Access Compliance Report

Public Rights-of-Way

(Curb Ramps)

Intersection ID: 7022	Main Street: CROSSPOINT_CENTER_LN	Cross Street: HUTCHISON-MCDONALD_RD	Location: NE
ADA ID: B38CF85ABC28	Ramp Type: Perp	Initial Pass/Fail: Fail	Overall Compliance: No
Severity Score: 12.5			
Codes/Mitigation Info/Possible Solution		Field Measurements/Component Compliance

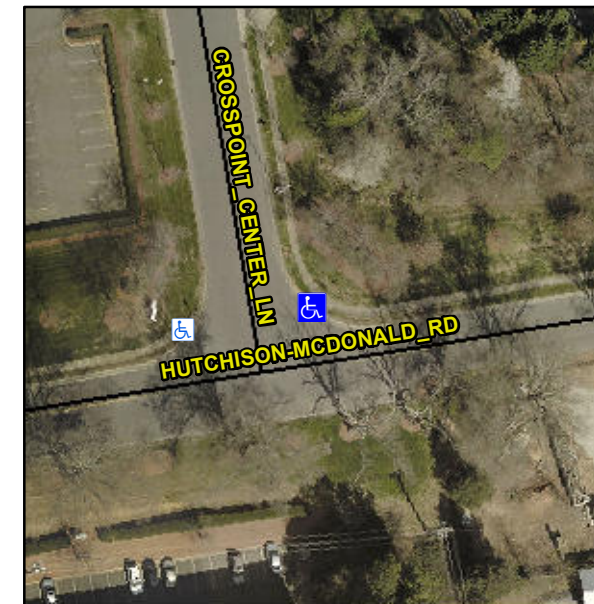
Not Found, R304.2.2

Compliance	Description	Data	Compliance	Description	Data
N/A	Ramp Length (in)	67.0	No	Ramp Slope (%)	9.0
Yes	Ramp Width (in)	48.0	Yes	Ramp XSlope (%)	0.7
N/A	Flare Type LT	N/A	N/A	Flare Type RT	N/A
N/A	Flare Slope LT (%)	N/A	N/A	Flare Slope RT (%)	N/A
N/A	Flare Traversable LT?	N/A	N/A	Flare Traversable RT?	N/A
N/A	Landing Length (in)	N/A	N/A	DWS Provided?	N/A
N/A	Landing Width (in)	N/A	N/A	DWS Contrast?	N/A
N/A	Landing Slope (%)	N/A	N/A	DWS Length (in)	N/A
N/A	Landing X Slope (%)	N/A	N/A	DWS Full Width?	N/A
N/A	Landing Curb? (Y/N)	N/A	N/A	DWS Offset (in)	N/A
N/A	Shared Landing?	N/A			
N/A	Gutter Ponding?	N/A	N/A	Gutter Slope (%)	N/A
N/A	Gutter Lip Ht (in)	0.5	N/A	Gutter X Slope (%)	N/A
N/A	Painted X Walk1?	No	N/A	Painted X Walk2?	N/A
	X Walk 1 Direction	To W		X Walk 2 Direction	N/A
N/A	X Walk 1 Width (in)	N/A	N/A	X Walk 2 Width (in)	N/A
	X Walk 1 Slope (%)	2.8		X Walk 2 Slope (%)	N/A
	X Walk 1 X Slope (%)	4.1		X Walk 2 X Slope (%)	N/A

Remove & Replace Entire Ramp.
